Kentucky Transportation Cabinet Value Engineering Study

Mountain Parkway Item No. 10-166.00 Magoffin County

Value Engineering Study Report

Study Dates: May 23-25, 2016

SKETCH OF PROPOSED ALTERNATIVE

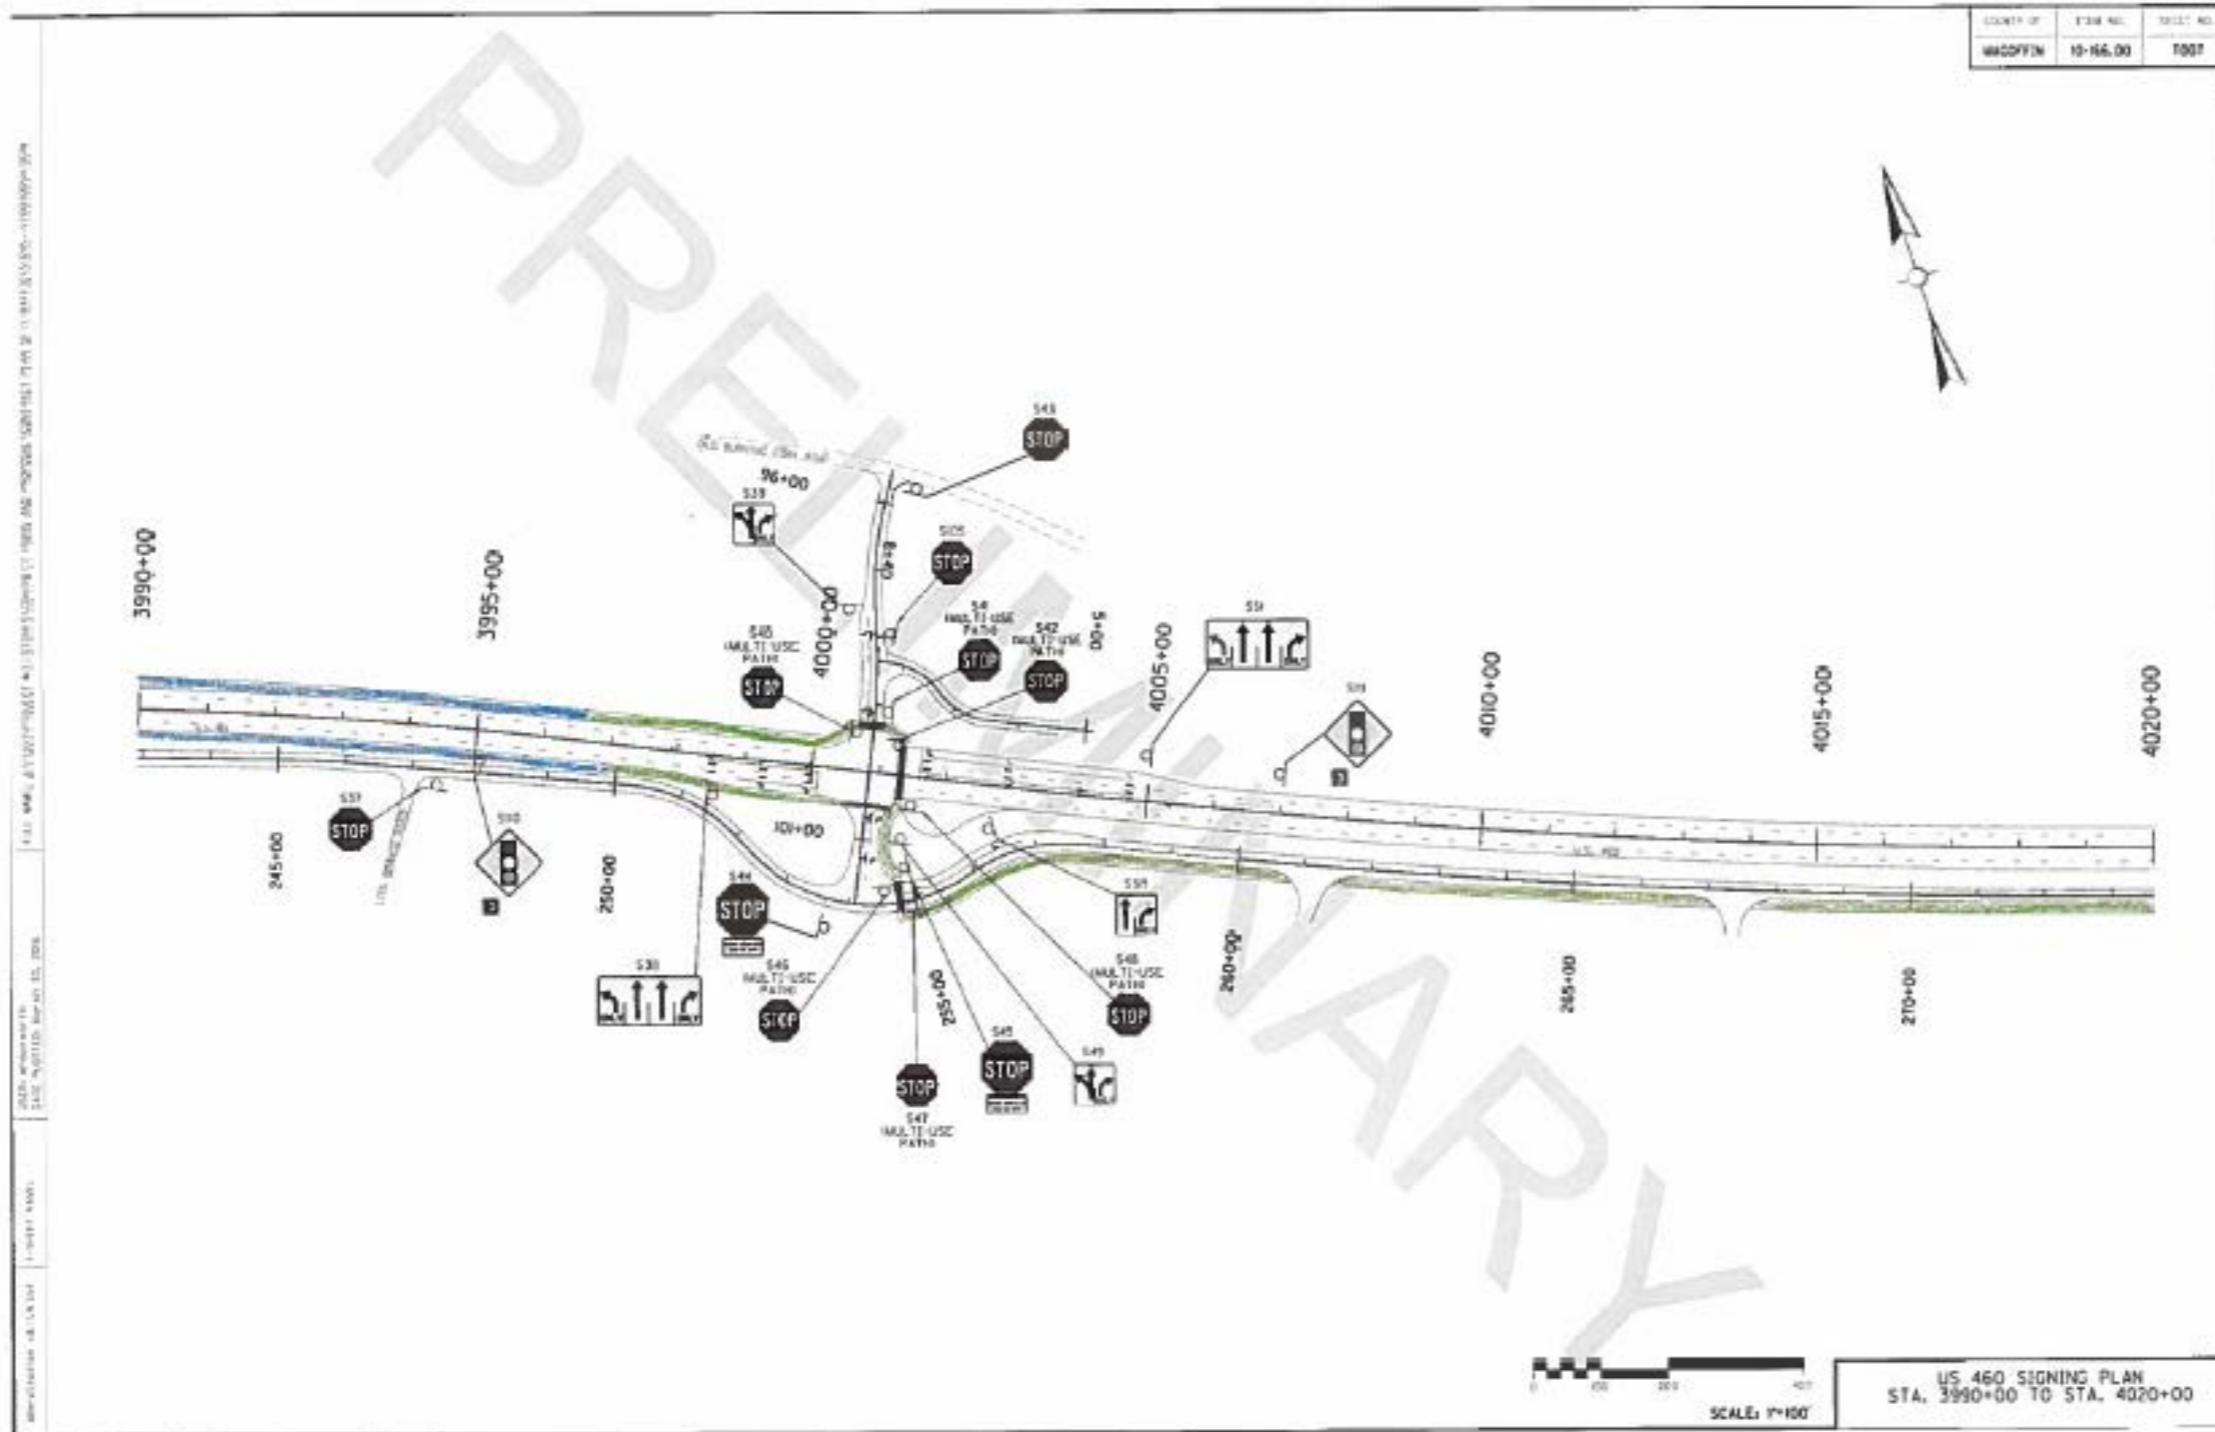
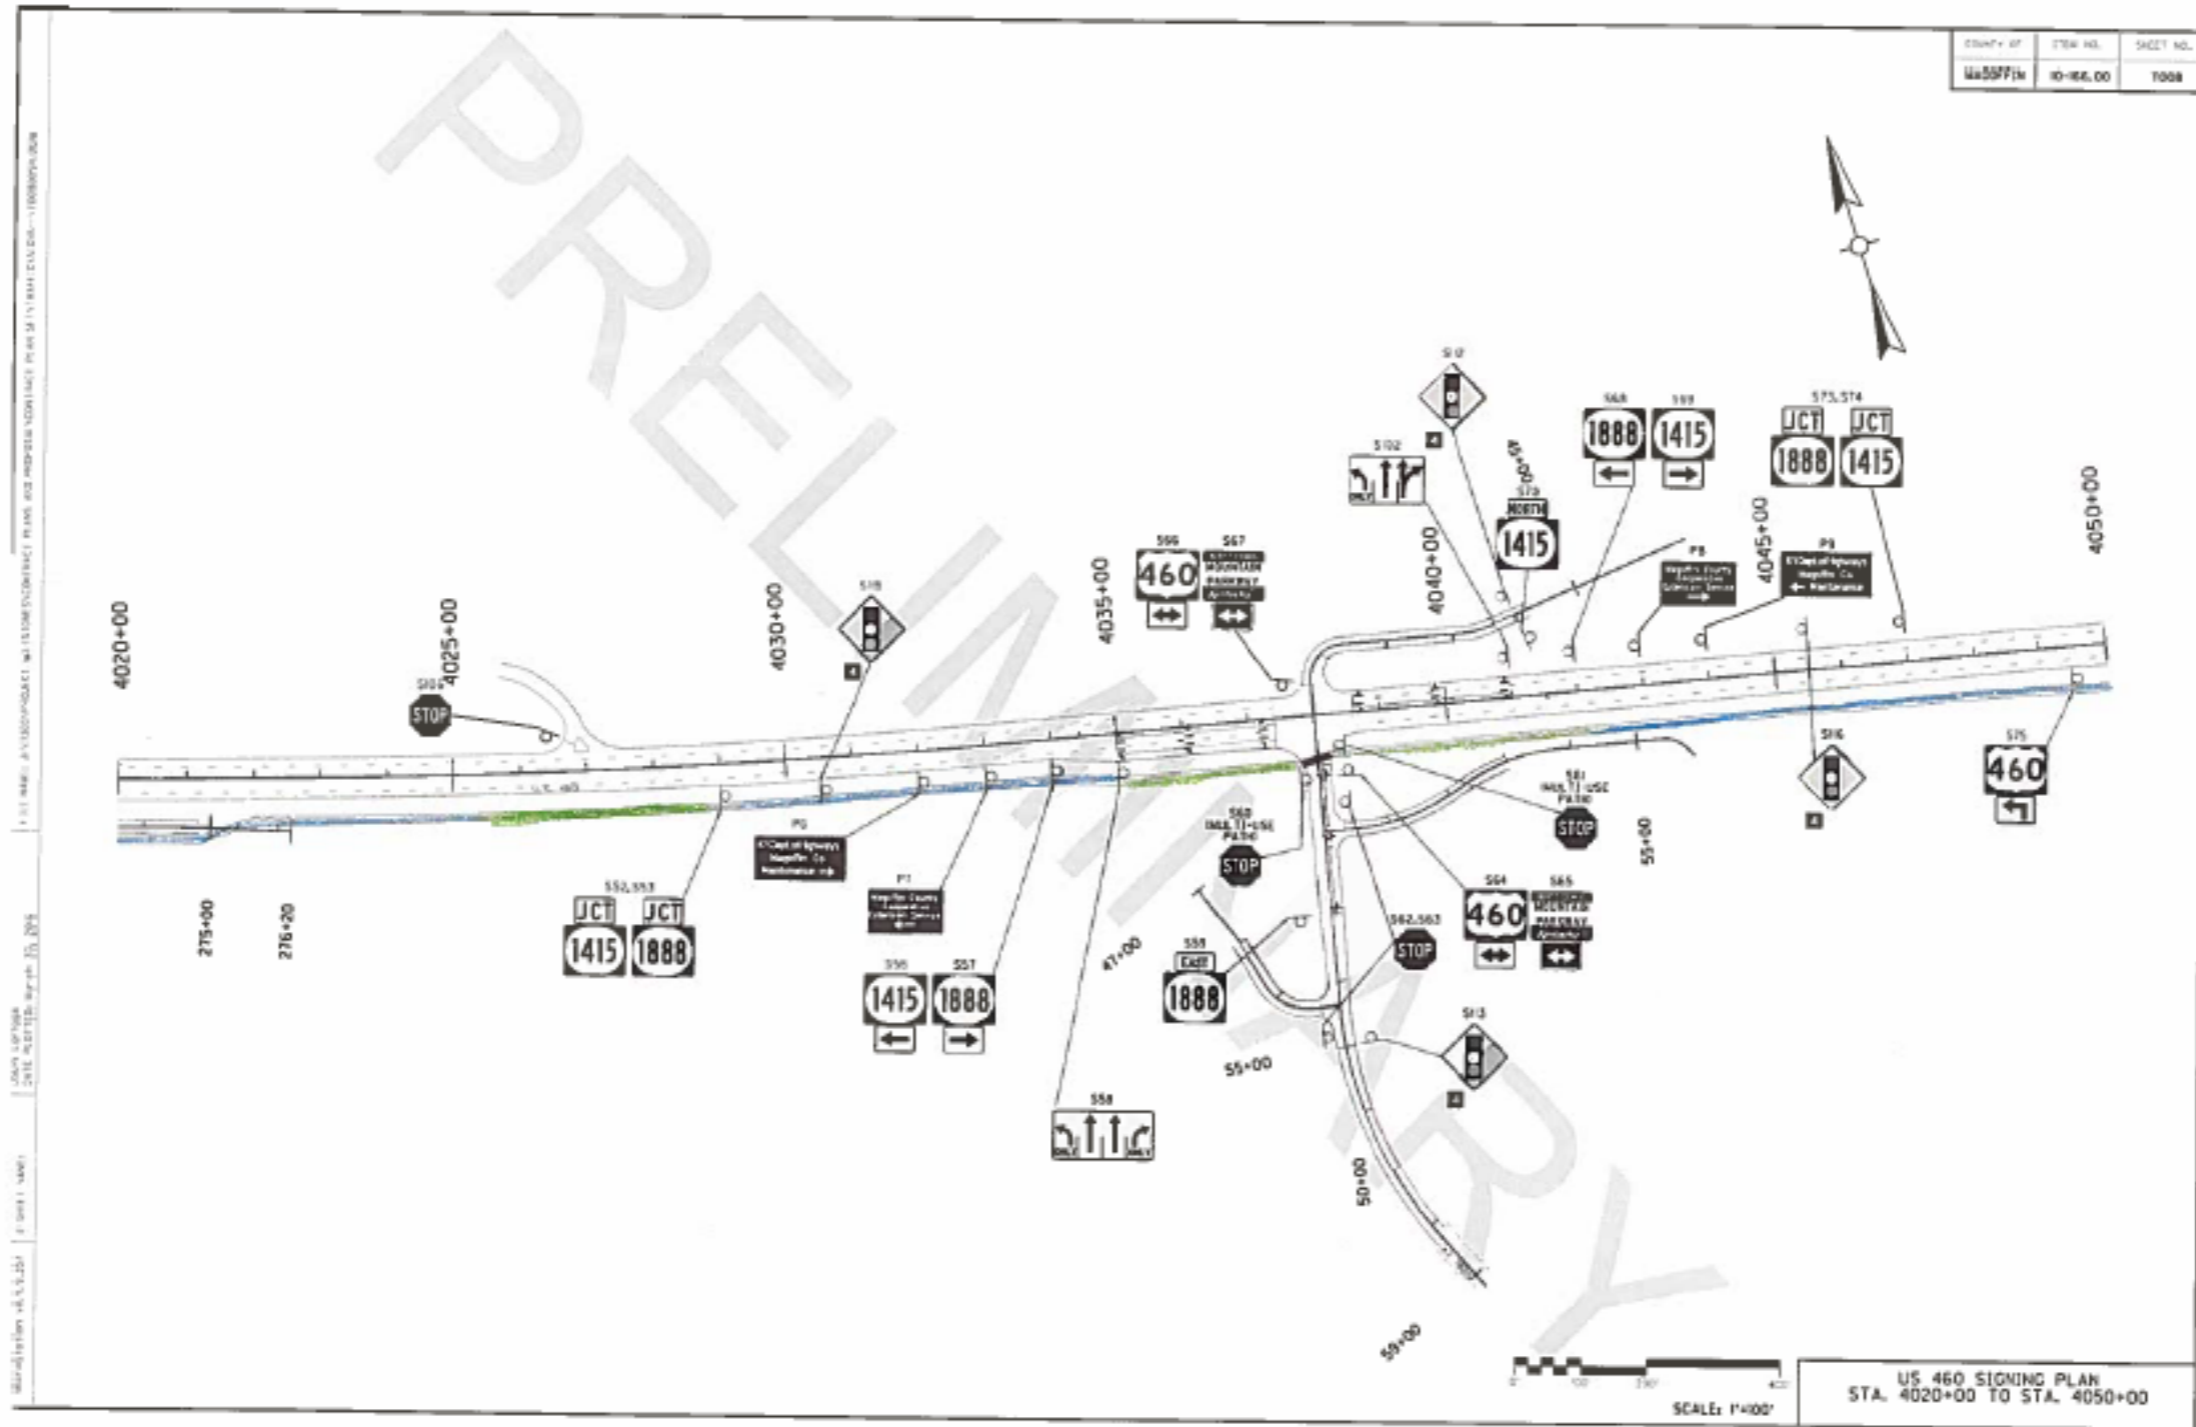
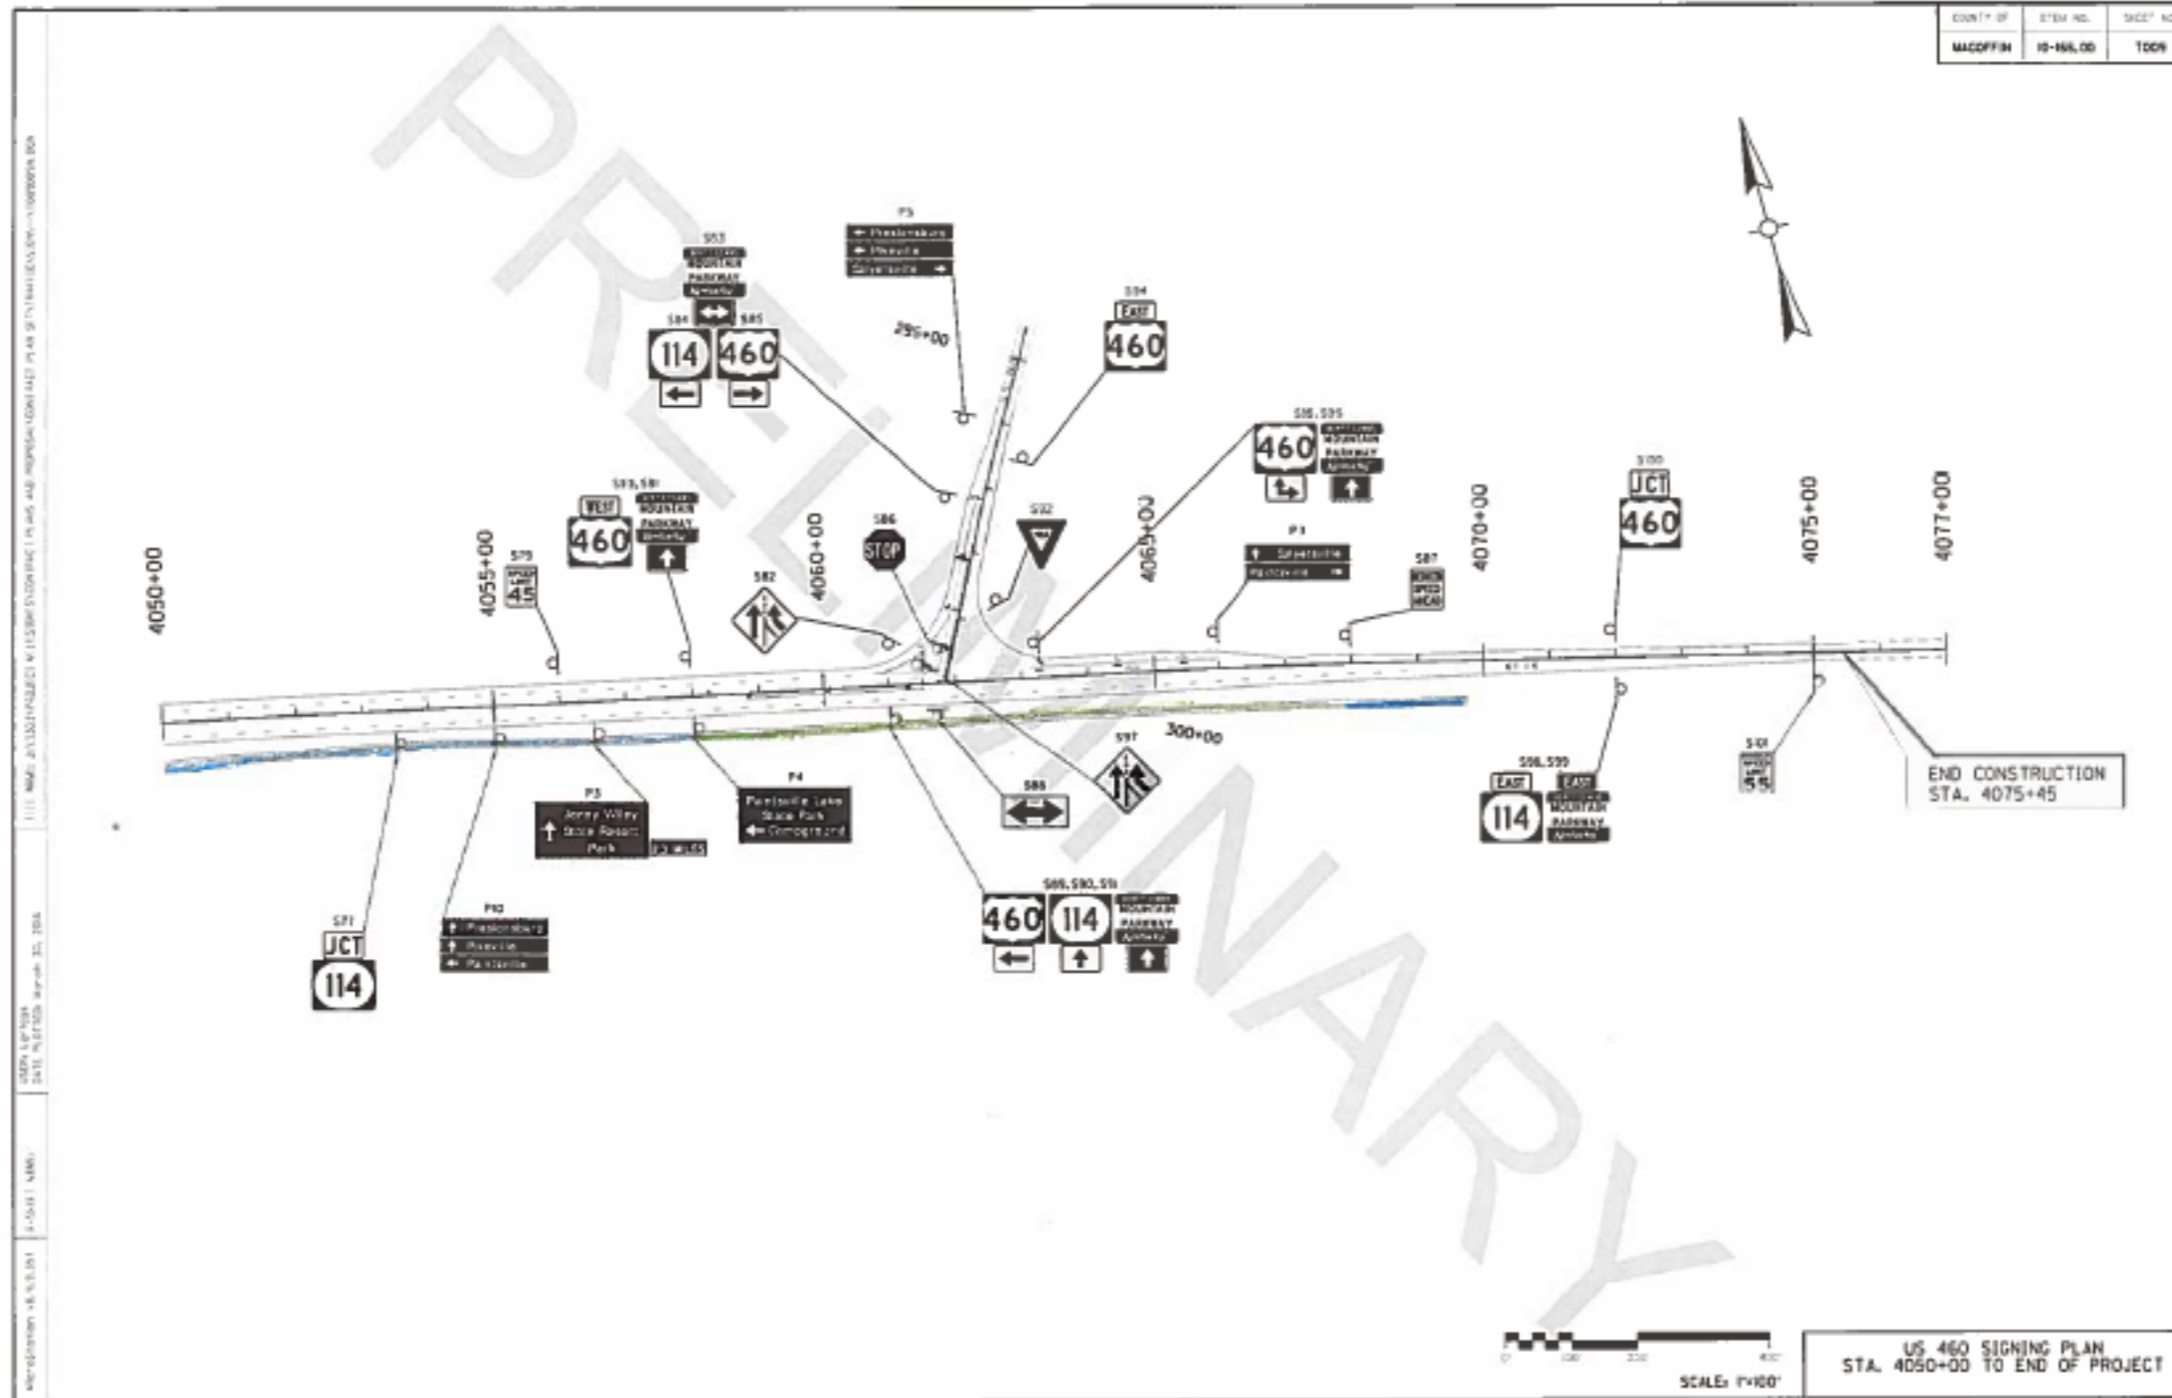
The location for these barriers would be in front of the high school and could be in front of the businesses that have the potential to generate pedestrian traffic. The suggested barrier is a wooden fence or another aesthetically pleasing barrier that fits in with the surroundings.

On the attached layouts, the orange line along the shared-use path channels the students from the high school to the crosswalk, which is the main area proposed. The cost has been calculated based on this approach only. The red line along the sidewalk and shared-use path does the same thing yet it is for the restaurant area of the project. This area is heavily suggested to have a fence like the high school has. The green areas are important areas to have a fence since it keeps pedestrians from crossing and it channelizes them to cross at crosswalks. The blue areas are suggested areas for a fence, yet are not required. The fence should be a woven wire type 1 fence with wooden planks added to the top, middle and bottom on the side facing the parkway or another material that is aesthetically pleasing and mixes well with the context of the area. The installation of the fence should follow section 721 of Kentucky's standard specification for Road and Bridge Construction. If these fences are added to the plans, then there should be a special supplemental note identifying where these fences are to be used. This will ensure that the contractor does not confuse this fence with the installation of regular woven wire type 1 fence.

The fences can be built within the existing right of way, since they are being built in between US 460 and the shared-use path. The major concern would be if the utilities would be impacted by the fence poles, and they do not affect the utilities. This is a concern more for the underground utilities then the above ground utilities. The pole placement is important because it should not affect the underground utilities. In addition, the fence should be built to protect the pedestrians from vehicles that go off the road and the fence should be aesthetically pleasing.
